Comment Letter 22 – John Watson

Re: Warehouses planned Sycamore Canyon Business Park (Bldg. 1 and 2

Sycamore Canyon Business Park (Bldg. 1 and 2)SCH no 2015081042

Response to Comment Letter 22 – John Watson

Figure A
Operational Noise Levels (Leq)
No Mitigation
33 degrees F 0% Humidity

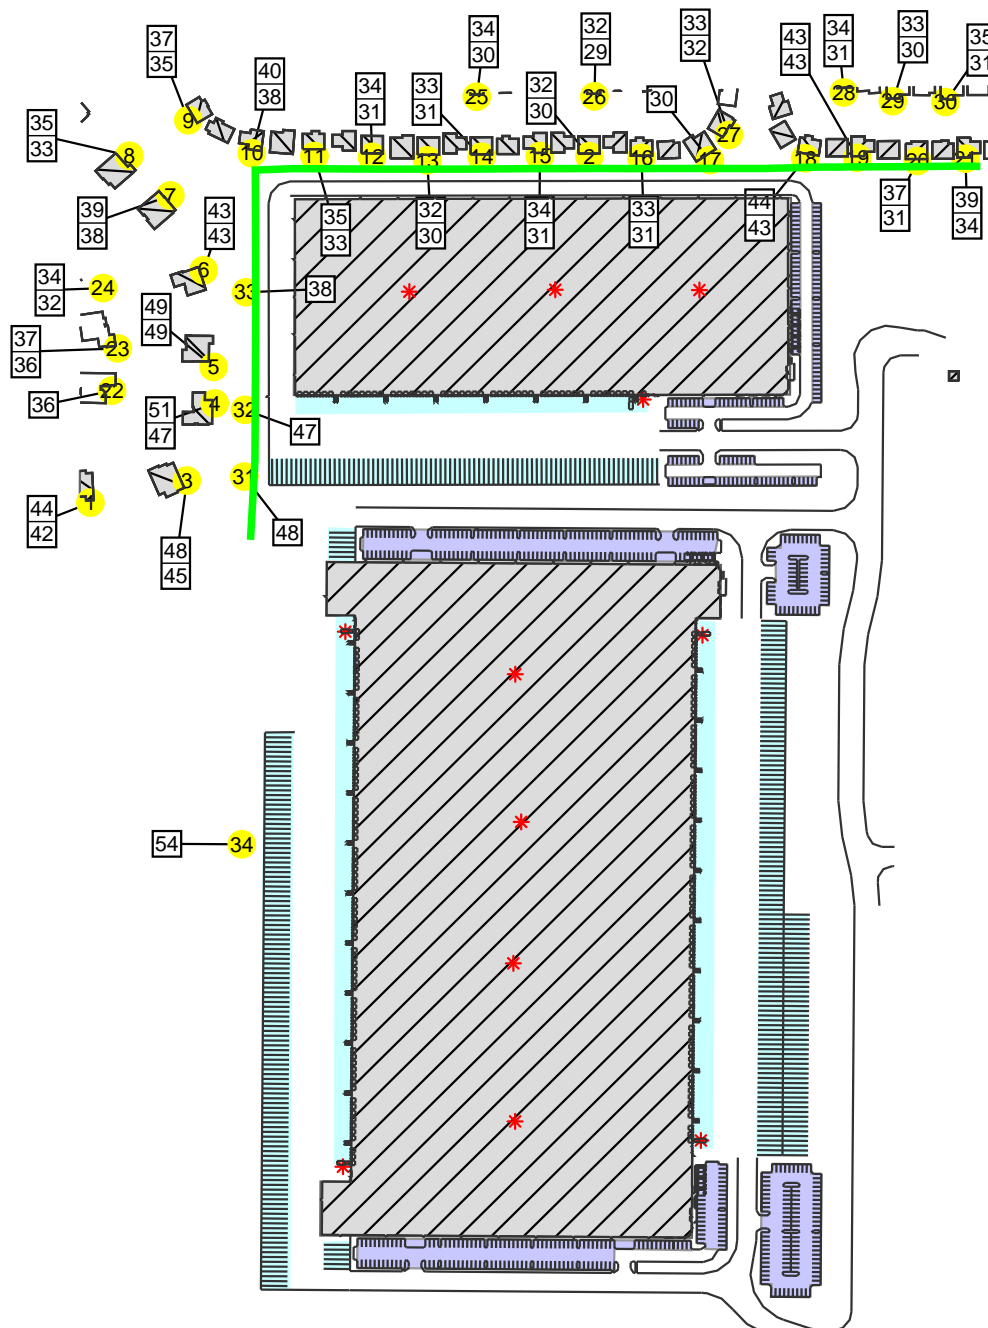
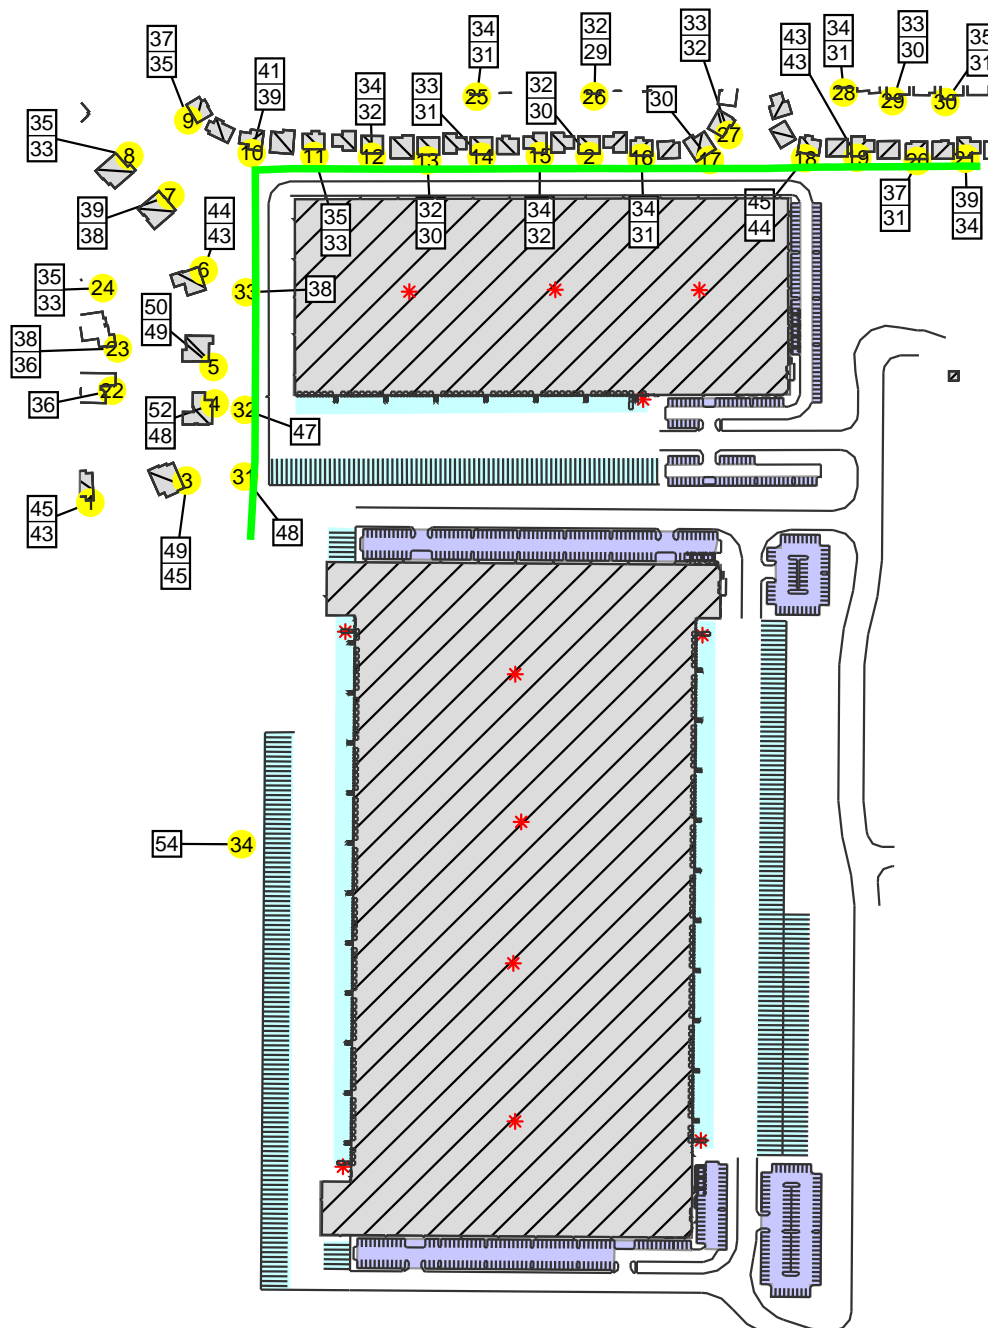
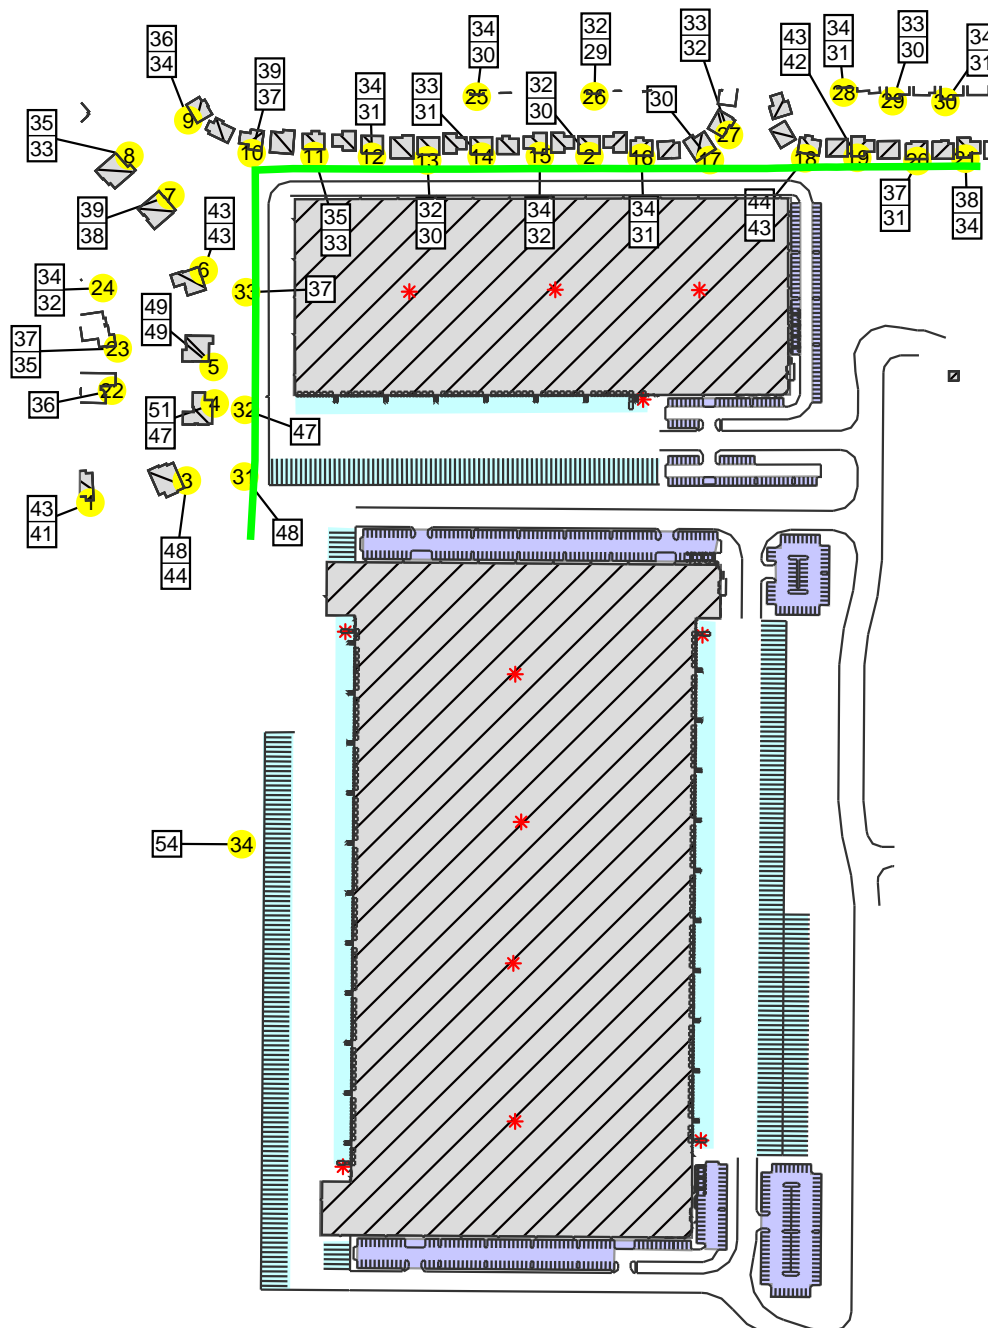
The Project's operational noise levels shown on DEIR **Figure 5.12-5 – Project Operational Noise Levels (Leq) No Mitigation** and **Figure 5.12-6 – Project Operational Noise Levels (Leq) with Mitigation** includes all noise associated with Project operations including: vehicles arriving, trucks and trailers moving around the Project site, back-up beepers, hitching and unhitching of trailers, and the movement of trailers into the loading docks averaged over a one hour period. During any given one hour period, there will be a maximum noise level (L_{max}). The L_{max} , generally results from an impulsive noise event, which is why the City's Municipal Code places time limits for noise events exceeding the exterior noise standard as discussed below.

Assuming noisiest conditions, noise levels at the first floor and second floor of all the receptors to the north and northwest of the Project site are below the City's daytime exterior noise standard of 55 dBA (see DEIR **Figure 5.12-5**). Without any restriction on nighttime use, as required by mitigation measure **MM NOI 15** (See Response to Comment 28-E above), Project-generated operational nighttime noise will exceed the City's nighttime exterior noise standard of 45 dBA at three residences: receptor locations 3, 4, and 5 as shown on DEIR **Figures 5.12-5 and 5.12-6**. With implementation of mitigation measure **MM NOI 15**, Project-generated operational noise will exceed the City's nighttime exterior noise standard at the second floor of two residences to the northwest of the Project site (shown as receptor nos. 3 and 4 on DEIR **Figures 5.12-5 and 5.12-6**). Thus, additional mitigation is required to reduce Project-generated operational noise at these locations. Implementation of mitigation measure **MM NOI 16**, which entails the installation of a noise barrier at the top of the slope of these receptor locations, would reduce operational noise levels to below the City's nighttime standard of 45 dBA (see DEIR **Figure 5.12-6**). However, as stated in the DEIR, installation of the noise barrier requires approval from the two property owners on whose land the proposed noise barrier will be installed and such approval to construct the barrier wall may not be provided by these property owners. Therefore, because neither the City nor the Project Applicant has the authority to implement mitigation measure **MM NOI 16**, the Project's operational nighttime noise impacts will remain significant and unavoidable. (DEIR, pp. 5.12-26 – 5.12-28, 5.12-48.)
